# VILLAGE OF HOMEWOOD

## MEMORANDUM

**Topic:** Case 25-40: Appearance Review, Park West Plaza, 3003-3029 W 183rd Street

**Figure 1: Proposed Elevation Changes, Front Elevation**

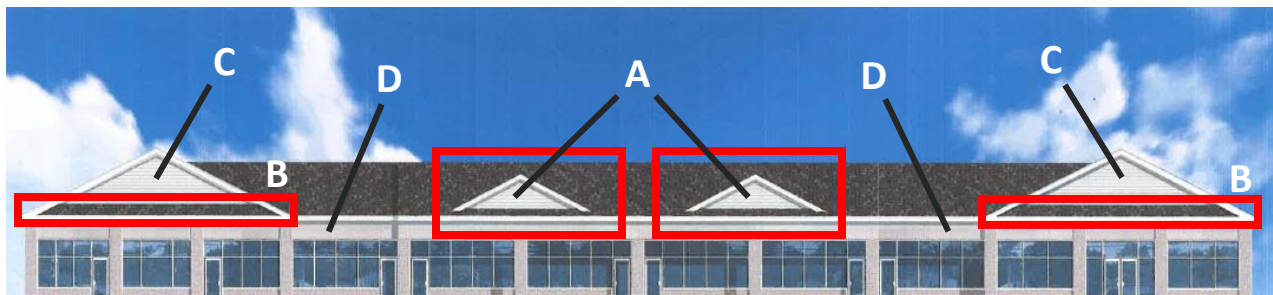
- **Roof Replacement and Redesign:** The applicant has proposed a full replacement of the roof to address code requirements and maintenance needs. The applicant has also proposed a redesign of the roof structure, including adding two dormers in the center of the building (**"A"** in Figure 1) and smaller pent roofs (**"B"** in Figure 1) under the two large gables at the east and west ends of the building. The roof will be fully replaced and will be clad in dark grey shingles.

- **Material Replacements:** Some materials on the building will be replaced to repair current damage on the front façade. The front of the two existing roof gables, currently clad in stucco, will be replaced with fiber cement boards (**"C"** in Figure 1). The fiber cement will be colored light grey. Larger fiber cement panels will replace stucco under the soffits of the building across the entire length of the front façade (**"D"** in Figure 1).

The current brick accent columns will be repaired and painted with a grey color. The bases of these columns, which are currently clad in stucco in poor condition, will be replaced with a thin-clad stone tile veneer. The existing brick arches on the west and east sides of the building will be partially removed and replaced with the new roof structures.

Other fixtures, such as downspouts and gutters, will be replaced and colored grey to match the proposed color palate of the building. New outdoor LED sconce lighting fixtures will be installed on the exterior of the building along the front elevation, replacing the four exterior lanterns currently installed on the building.
